# Illinois Department of Transportation

SUBJECT: FAI Route 94/90  
Project ACIM-094-3(398)055  
Section (1818, ETC, 2324.6-1P)R-9  
Cook County  
Contract No. 62302  
Item No. 2X, October 7, 2005 Letting  
Addendum B

## NOTICE TO PROSPECTIVE BIDDERS:

Attached is an addendum to the plans or proposal. This addendum involves revised and/or added material.

**BALLAST DETAIL** (Added 09-27-2005)

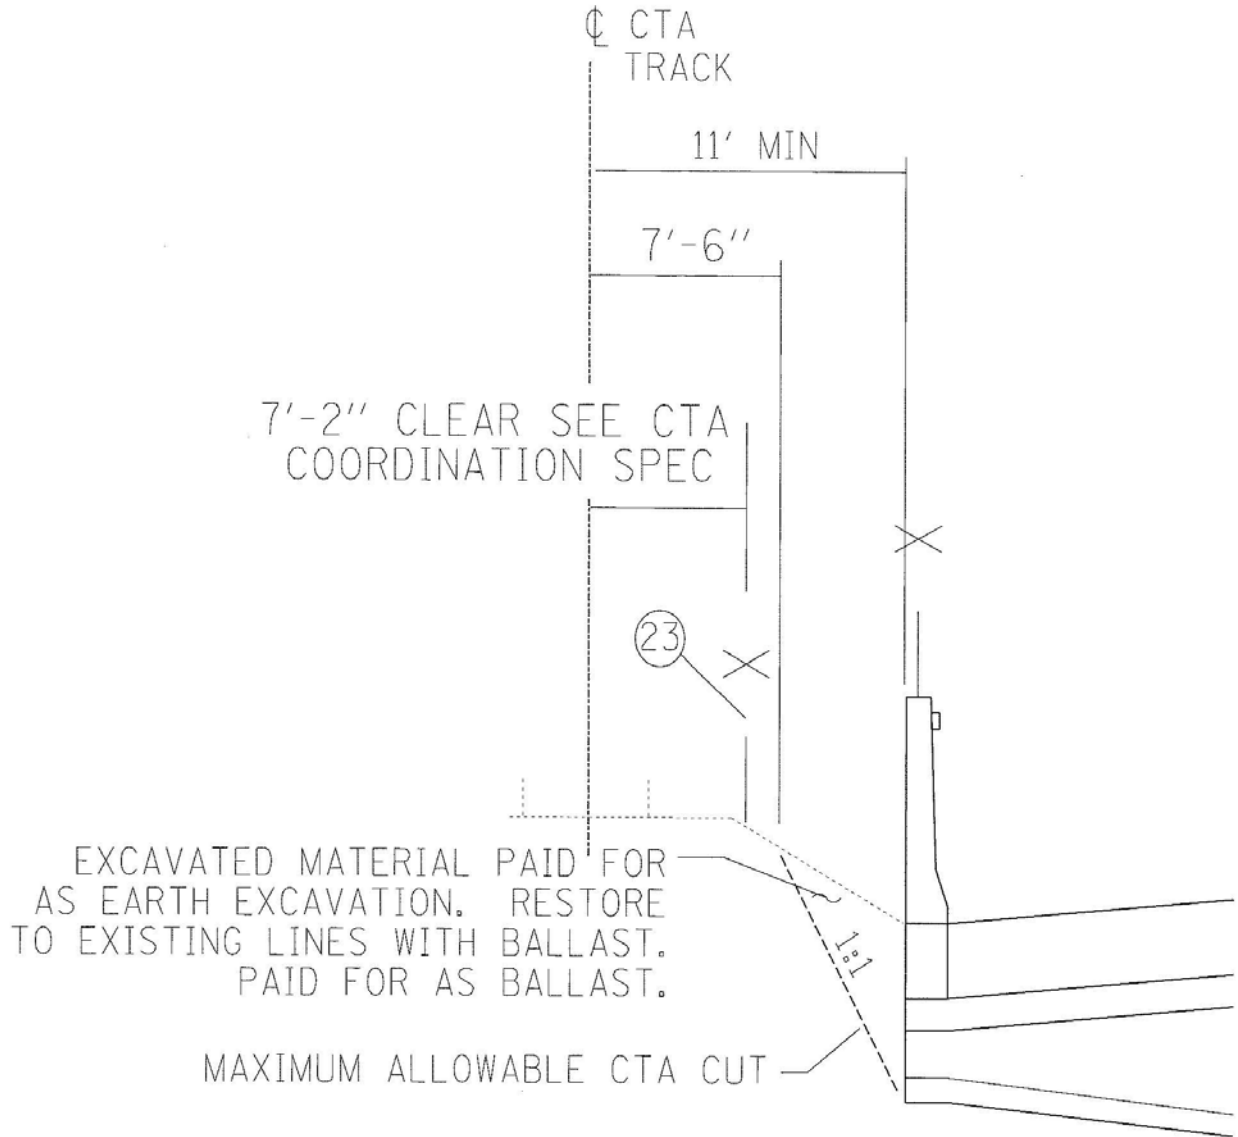
## **BALLAST**

Prepared ballast shall conform to AREMA Size No. 4, of nominal size 1 1/2 inches to 3/4 inch, uniformly graded within the following limits:

Ballast material shall be placed and compacted in layers not more than 6 inches compacted thickness.
